Amendments to the System Strength Impact Assessment Guidelines

Draft Report and Determination

Notice of Second Stage Consultation – Amendments to the System Strength Impact Assessment Guidelines

Figure 1: Calculating System Strength Locational Factor

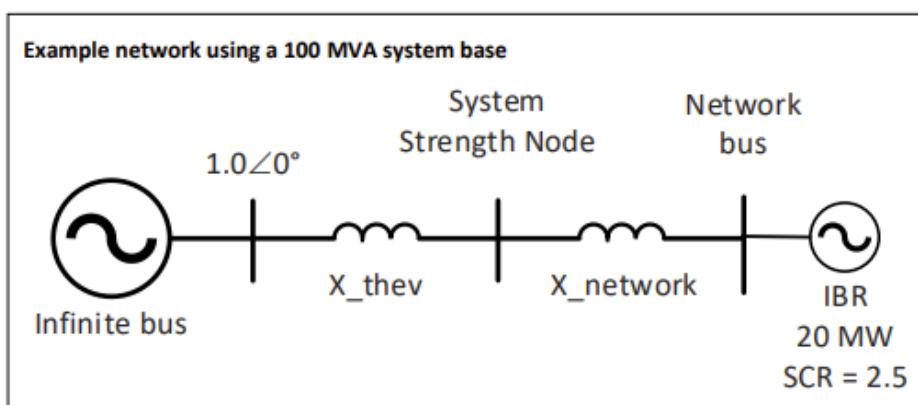
Based on the proposed methodology, the SSLF will vary depending on what is assumed as the base fault level at a given connection point. The more fault current that is required to be transferred across the network impedance (between the SSN and 4.6.6 Connection Point), the higher the SSLF will become. This is demonstrated by the example in Figure 1. The issue being highlighted is that SSLF will not be a constant value if fault level requirements increase at a particular connection point over time, for example, if more than one IBR connects at the same location.

Because SSNs must be located on the transmission network, it is likely that most distribution network connections will have high SSLFs due to the impedance of upstream assets. This will encourage Applicants to self-mitigate even if this is not the most efficient option and potentially dilutes the benefits intended by the Amending Rule. For example, it could result in multiple small synchronous condensers being installed throughout distribution networks which is not only inefficient, but could also lead to high fault level issues.

TasNetworks is concerned that there are unintended consequences for future developments in some parts of the network – particularly distribution networks, if there is relatively high impedance between the proposed connection points and the transmission network SSNs. Where possible, the SSIAG must address this unintended consequence of the calculation methodology. A suggestion on how the materiality threshold could help solve this issue is provided in the next section.
